**FINAL DRAINAGE REPORT  
FOR  
MC CLINTOCK STATION LOT A  
(VOLLMER ROAD RV STORAGE)**

**May 2023  
Project No. 25251.00**

**PCD File No. PPR-2245**

PROPOSED DRAINAGE MAP  
VOLLMER RV STORAGE  
JOB NO. 25251.00  
05/01/2023  
SHEET 1 OF 1

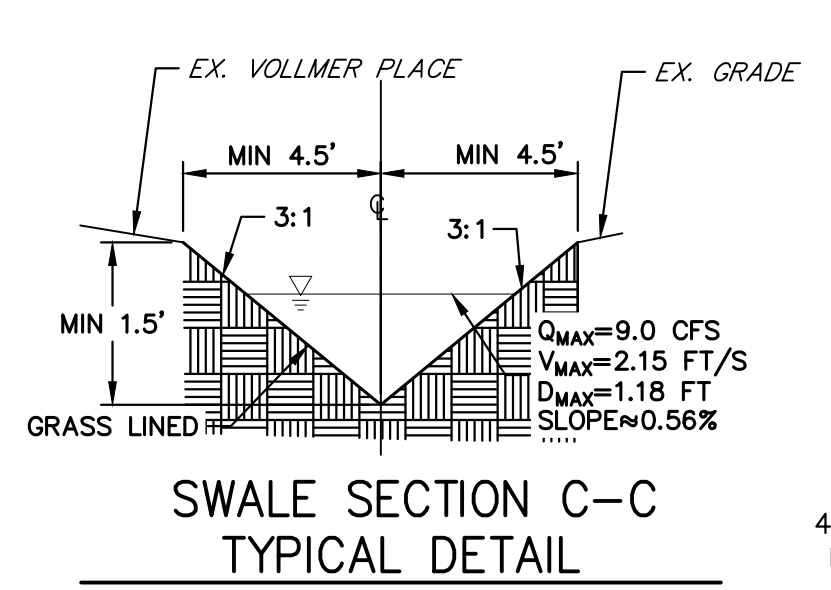
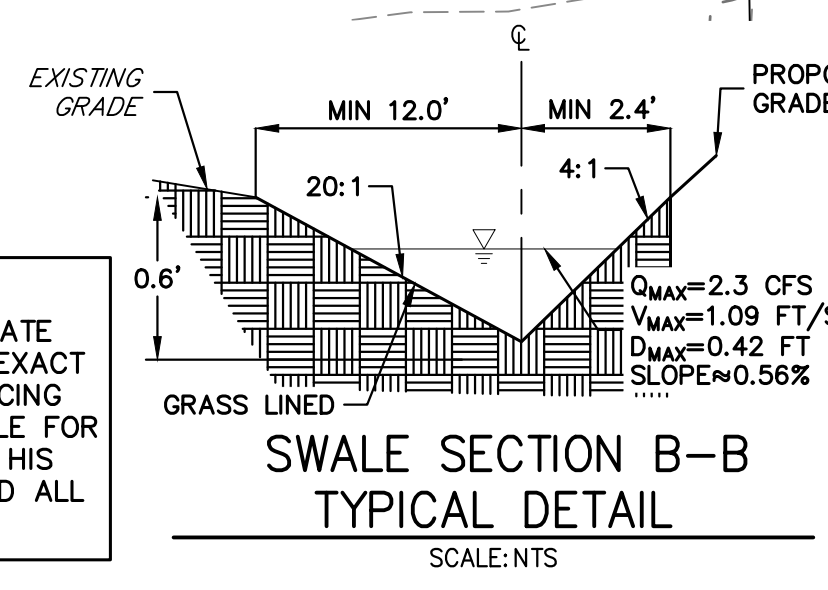
Drainage report referenced landscape areas where flows would be routed through. Show and label these areas on map.

Label proposed culvert

Show existing electrical line

Addressed, report statement revised

Addressed, label added

Addressed, Electrical line shown
